TECHNICAL SERVICE BULLETIN

Seat Pan Looseness, Lateral Movement, And/Or Clunk/Thump Noise On Turns

22-2101

Lincoln
2017-2020 Continental
2018-2022 Navigator

Figure 1

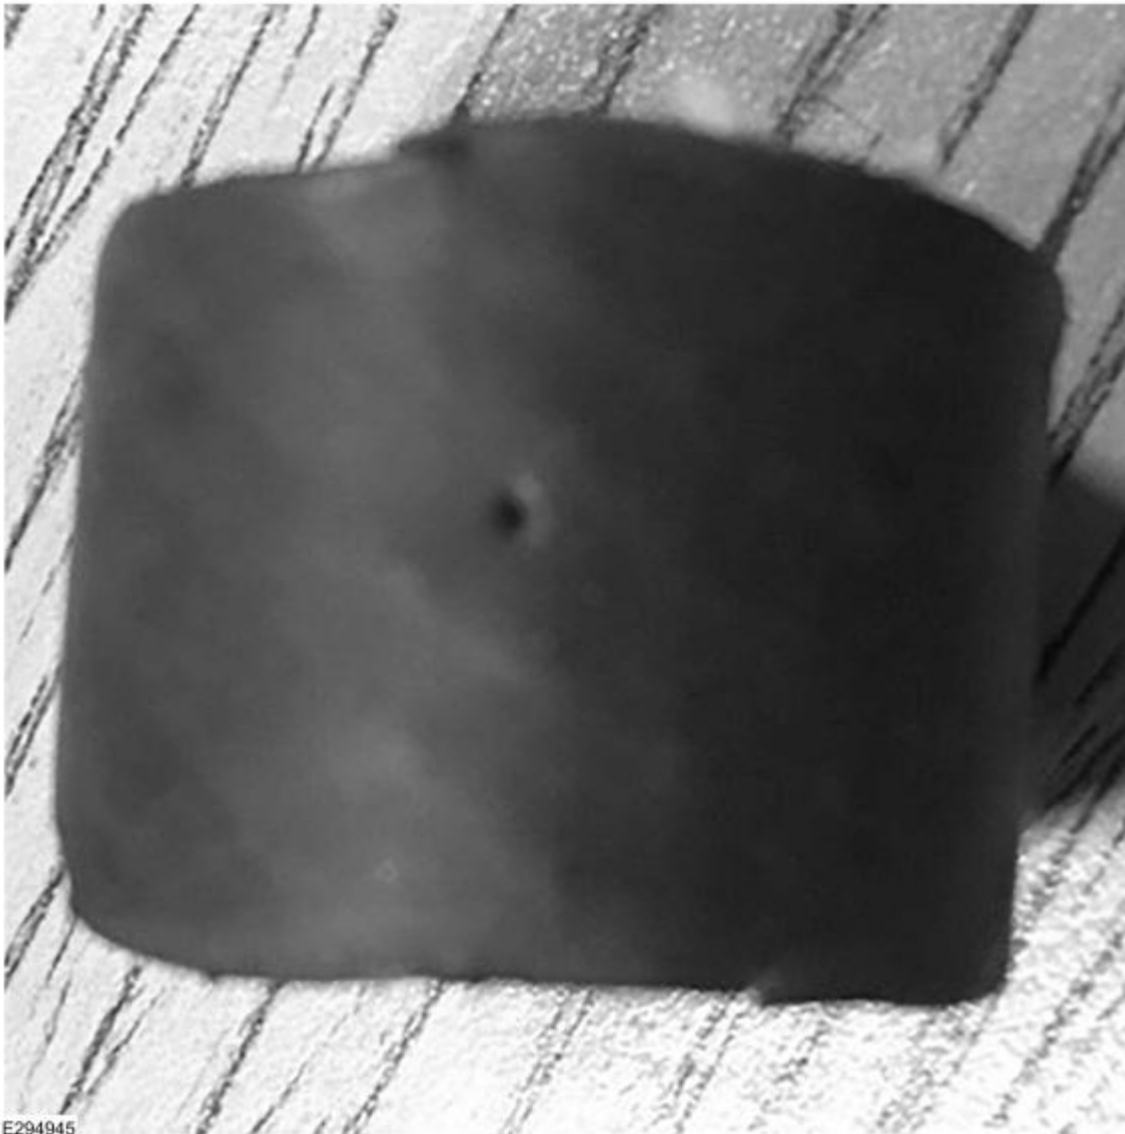
2. Remove the driver front seat module (DSM) and passenger front seat module (SCMB). Refer to Workshop Manual (WSM), Section 501-10A.
3. Remove the seat module mounting bracket.
4. Cut a 25.4 mm (1 in.) long piece of 19 mm (3/4 in.) diameter heater hose. (Figure 1)

Figure 2

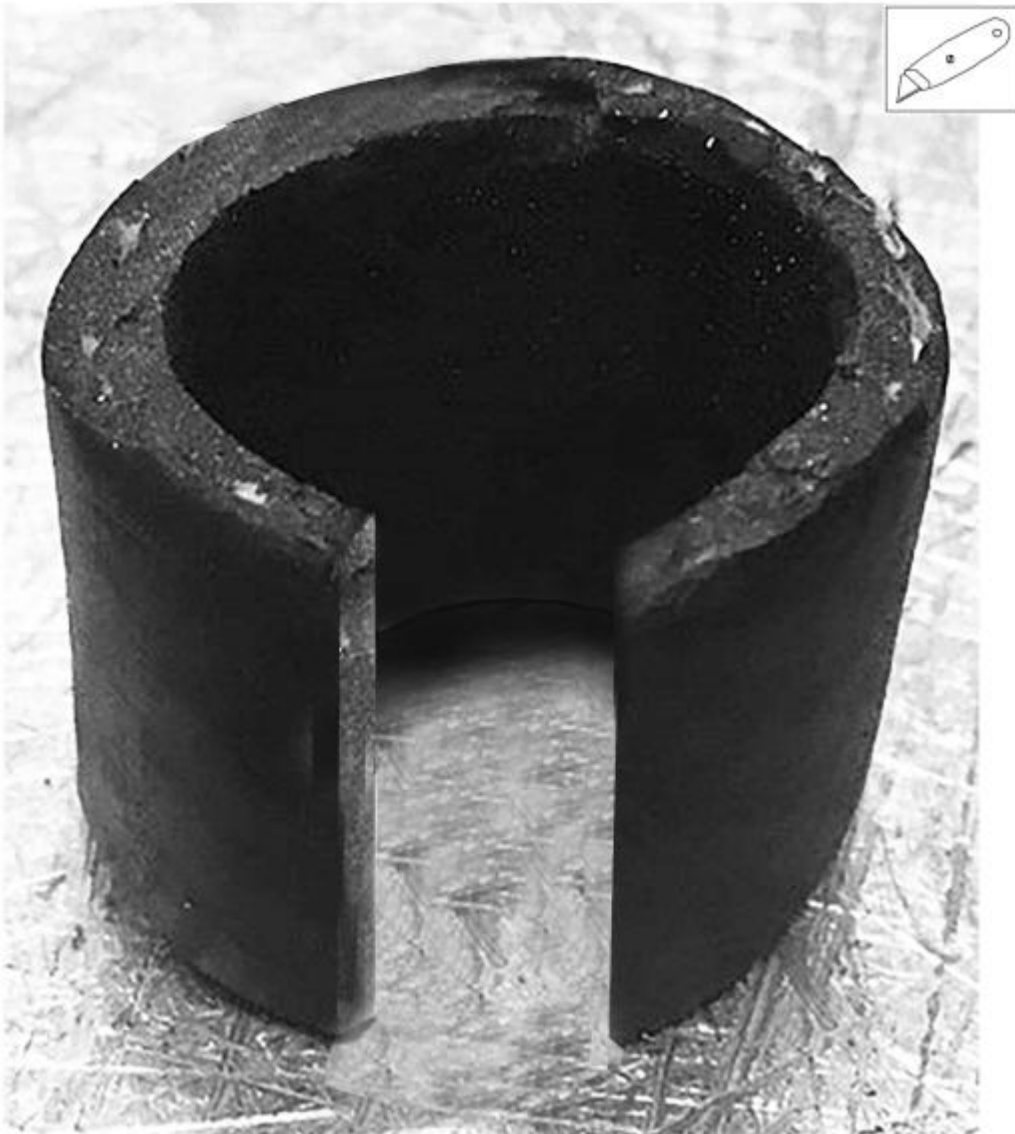
5. Cut a slit in the 25.4 mm (1 in.) piece. (Figure 2)

Figure 3

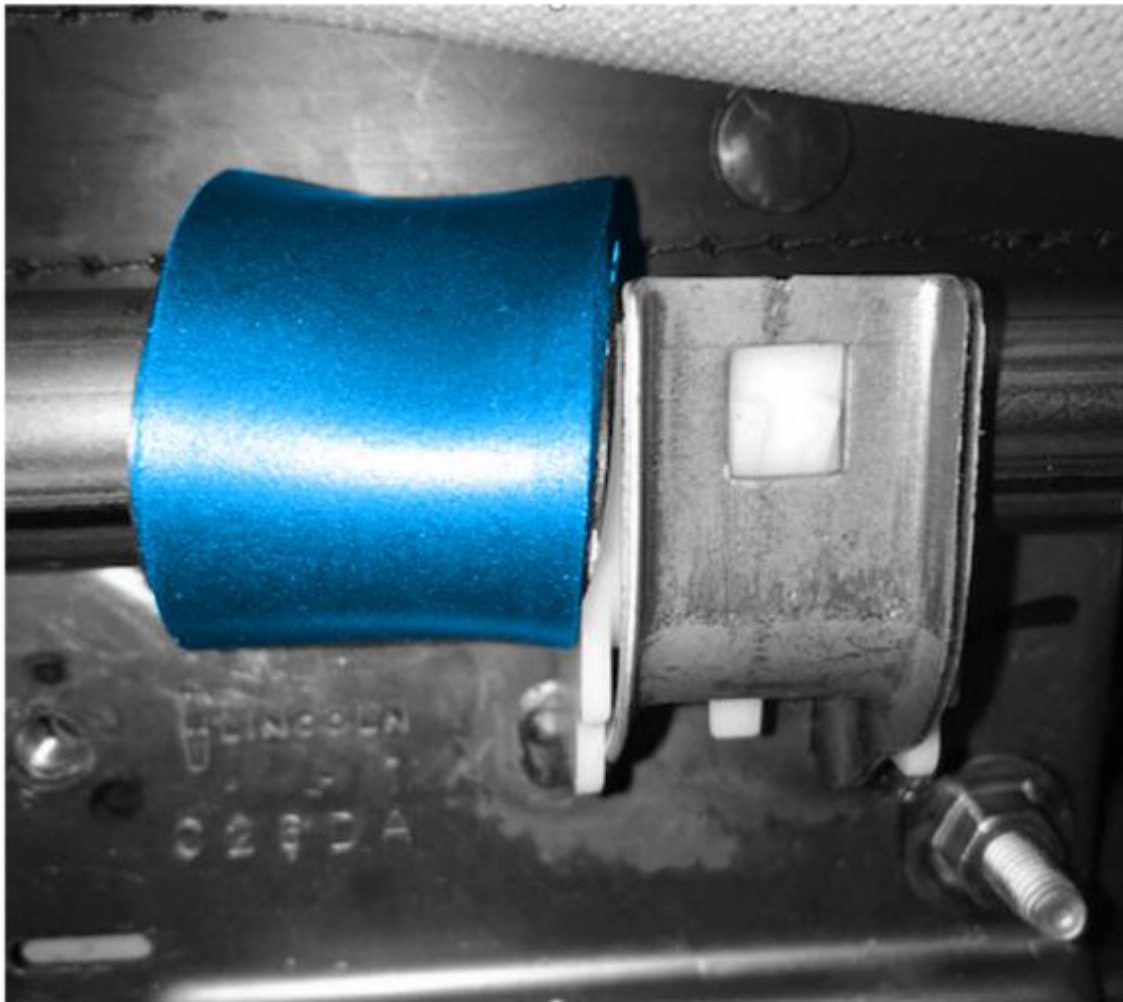
6. Install the hose over the front cross tube. (Figure 3)
